CHANGE ORDER FORM

4

Project: Ravenswood MS Realignment PH 1
Bid No.: 2018-19-004

Date: March 26, 2020
DSA File No.: 01-117275
DSA Appl. No.: 01-117275

DATE: 04-11-2017
PROJECT: RAVENSWOOD MS REALIGNMENT PHASE 1
SHEET: E10.0

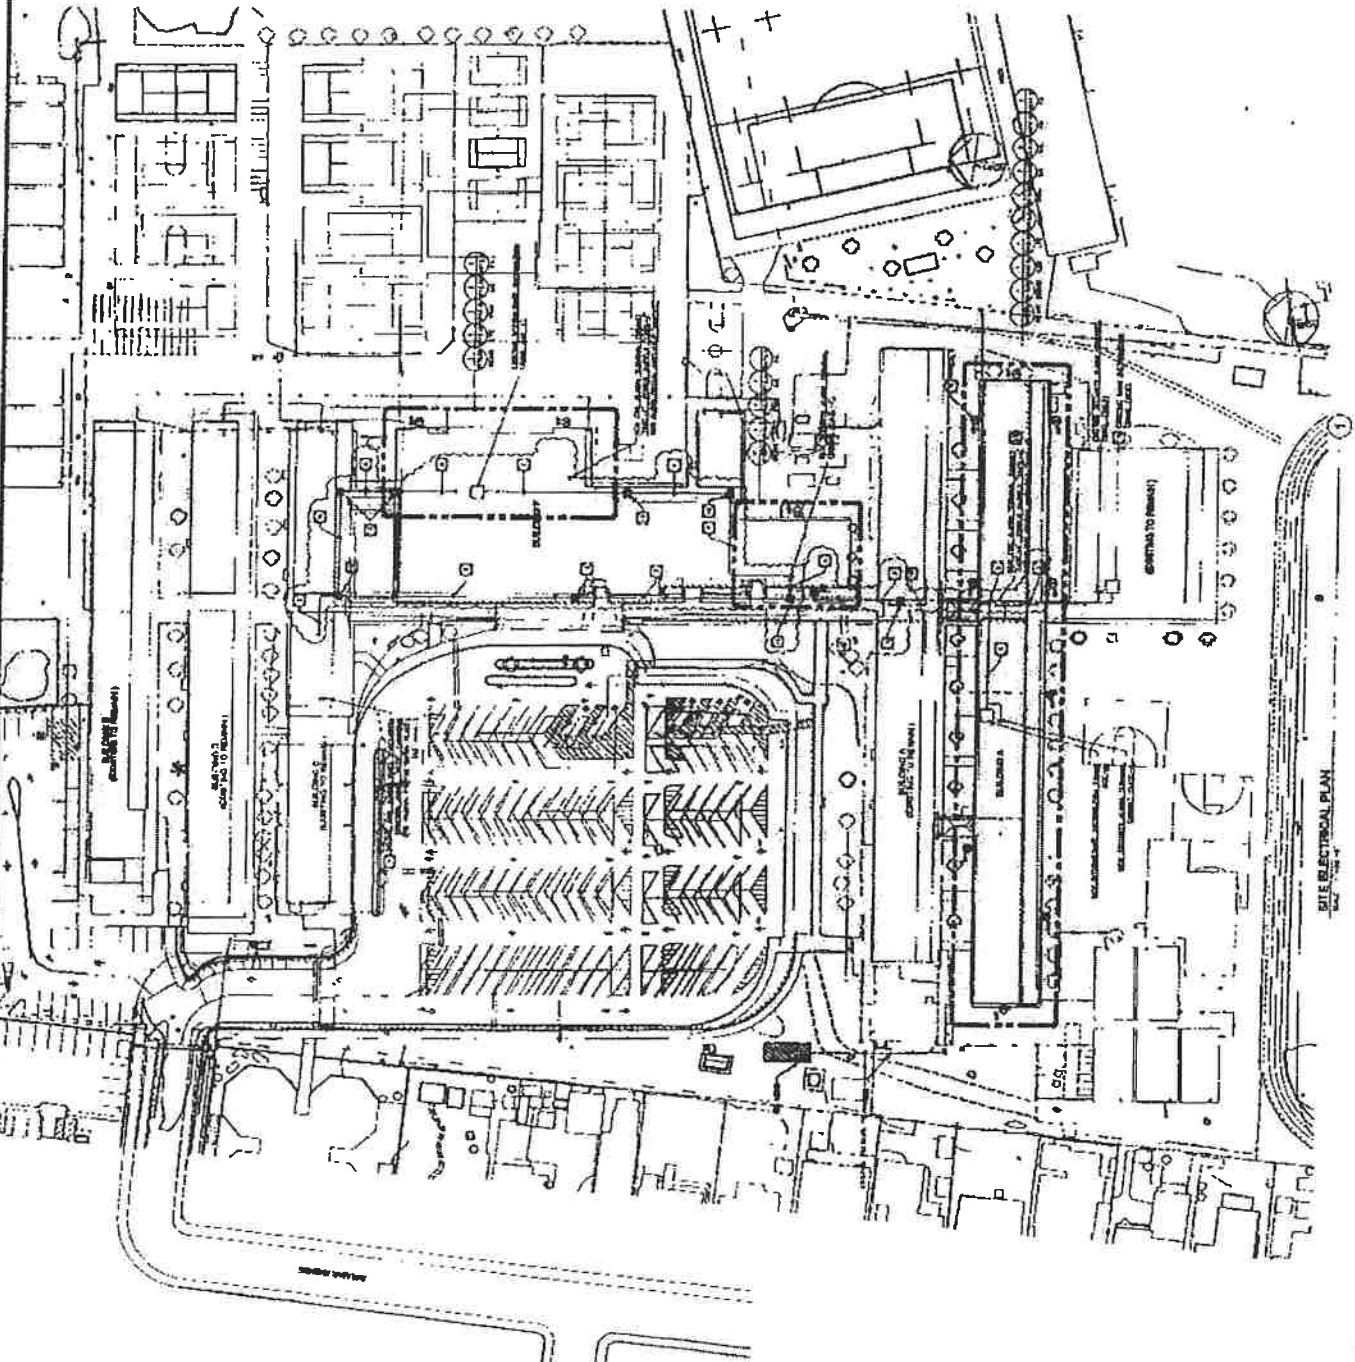
CCD-12 & RFI-128, Spartan Drawings E10.0(revised),
EF12.2B (Revised), EFA0.19Revised), EFA0.3(Revised),
EFA0.4 (Revised), EFA12.1A (Revised):
Added Fire Alarm Devices for installation by Signa West
Systems, Raceway by San Pris Electric Inc.
Fire Alarm connections to Buildings A, B, & C.

BUILDING F FLOOR PLAN - SOUTH
Scale: 1/8"=1'-0"
Date: 08-11-18
Drawn by: [Name]
Checked by: [Name]
Project: [Name]

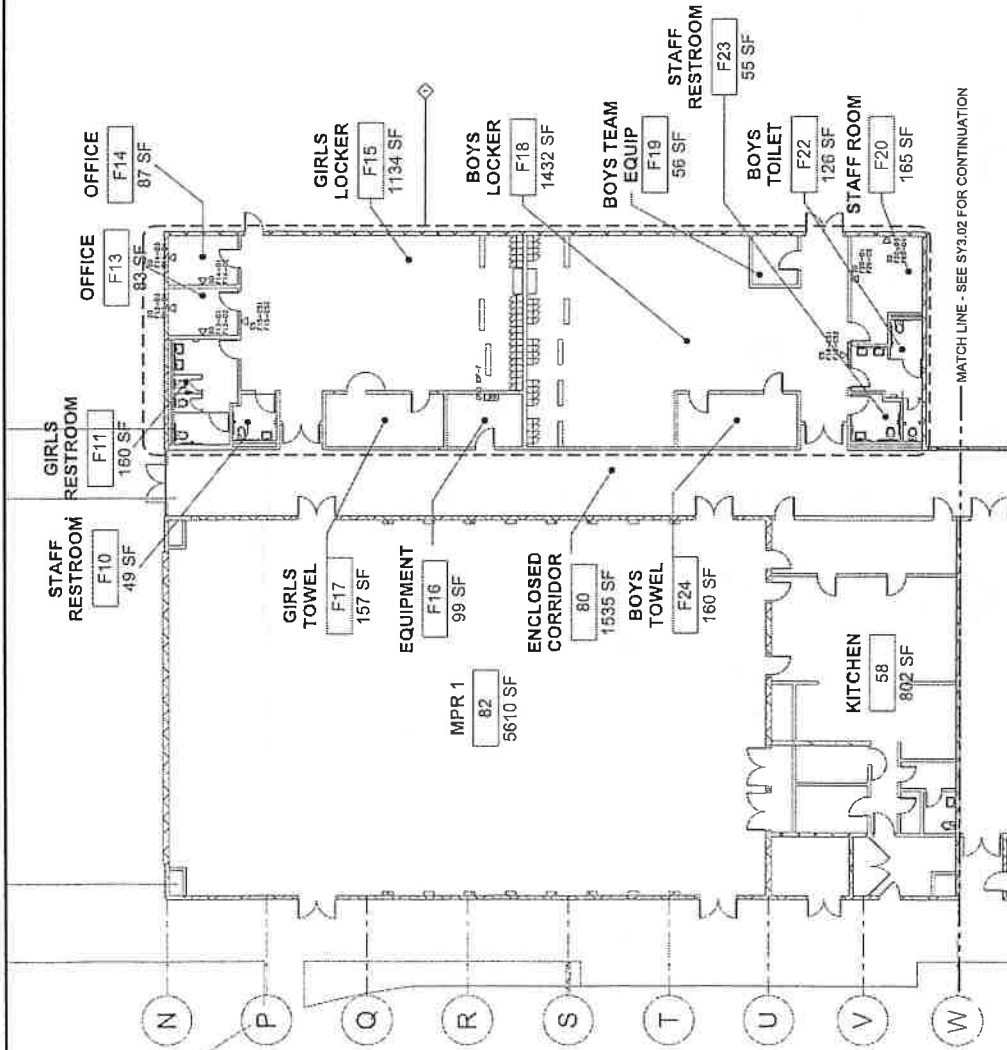
IDF-F: All Fiber work by others. Relocation of Existing IDF F is by owner to New IDF F location in Equipment F16 per meeting onsite. The locker rooms have changed from (25) data drops to (16) data drop per RFI Response 158. Credit for the original fiber from Bldg A to Bldg K issued.
 Attached Revised Drawing: (16) data drops between the Boys & Girls locker rooms.
